Access Compliance Report

Public Rights-of-Way

(Pedestrian Signals)

Intersection ID: N/A	Main Street:	Cross Street: N/A	Location: N/A
ADA ID: 90FF3DA58193	Signal Type: One Push Button-Non APS	Overall Compliance: No	Severity Score: BTN 1: N/A BTN 2: N/A No BTN: N/A
Codes/Mitigation Info/Possible Solution		Field Measurements/Component Compliance

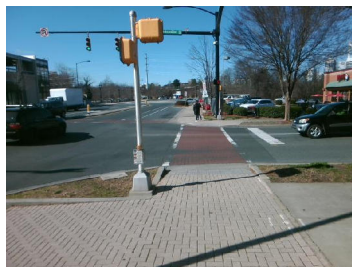
PROW/ADA: TMUTCD 4e.08, R404.2, R404.3, R406.2

Compliance	Description	Data	Compliance	Description	Data
	Button Count	Button1	N/A	Distant to Additional Button (in)	N/A
	Additional Button Present?	No		Additional Button ID	N/A
N/A	Signal Buttons Required?	N/A	N/A	Additional Ped Posts Required	N/A
	How Many Ped Street Xings?	2		Located In An Island/Median?	No
N/A	B 1 Sign Present?	Yes	N/A	B 2 Sign Present?	N/A
Yes	B 1 Sign Purpose?	Yes	N/A	B 2 Sign Purpose?	N/A
Yes	B 1 Sign Lettering & Contrast?	Yes	N/A	B 2 Sign Lettering & Contrast?	N/A
Yes	B 1 Parallel To XWalk?	Yes	N/A	B 2 Parallel To XWalk?	N/A
Yes	B 1 PAR to Button?	Yes	N/A	B 2 PAR to Button?	N/A
Yes	B 1 PAR to XWalk?	Yes	N/A	B 2 PAR to XWalk?	N/A
Yes	B 1 Clear Floor Space?	Yes	N/A	B 2 Clear Floor Space?	N/A
N/A	B 1 FWD Approach?	Yes	N/A	B 2 FWD Approach?	N/A
N/A	B 1 FWD Approach Constrained?	No	N/A	B 2 FWD Approach Constrained?	N/A
No	B 1 FWD Approach Reach (in)	10.0	N/A	B 2 FWD Approach Reach (in)	N/A

N/A	B 1 FWD Approach Width (in)	N/A	N/A	B 2 FWD Approach Width (in)	N/A
N/A	B 1 FWD Approach Obstruction?	Yes	N/A	B 2 FWD Approach Obstruction?	N/A
N/A	B 1 FWD Approach Obstruction Dist (in)	8.0	N/A	B 2 FWD Approach ObstructionDist (in)	N/A
N/A	B 1 PARA Approach?	Yes	N/A	B 2 PARA Approach?	N/A
N/A	B 1 PARA Approach Constrained?	No	N/A	B 2 PARA Approach Constrained?	N/A
Yes	B 1 PARA Approach Reach (in)	10.0	N/A	B 2 PARA Approach Reach (in)	N/A
N/A	B 1 PARA Approach Width (in)	N/A	N/A	B 2 PARA Approach Width (in)	N/A
N/A	B 1 PARA Approach Obstruction?	Yes	N/A	B 2 PARA Approach Obstruction?	N/A
N/A	B 1 PARA Approach Obstruction Dist (in)	8.0	N/A	B 2 PARA Approach ObstructionDist (in)	N/A
No	B 1 Clear Floor Space Slope (%)	6.7	N/A	B 2 Clear Floor Space Slope (%)	N/A
Yes	B 1 Clear Floor Space XSlope (%)	0.9	N/A	B 2 Clear Floor Space XSlope (%)	N/A
N/A	B 1 PAR Slope (%)	0.5	N/A	B 2 PAR Slope (%)	N/A
Yes	B 1 Height (in)	39.0	N/A	B 2 Height (in)	N/A

Yes	B 1 Clear Xing Direction?	ClearlyMarked	N/A	B 2 Clear Xing Direction?	N/A
	B 1 Crossing Direction	To S		B 2 Crossing Direction	N/A
Yes	B 1 DistanceTo XWalk (in)	19.0	N/A	B 2 DistanceTo XWalk (in)	N/A
No	B 1 DistanceTo Curb (in)	133.0	N/A	B 2 DistanceTo Curb (in)	N/A
Yes	B 1 Diameter (in)	2.0	N/A	B 2 Diameter (in)	N/A

Possible Solutions: Replace Signal Push Button With APS Button on New Post. Remove & Relocate Sign.
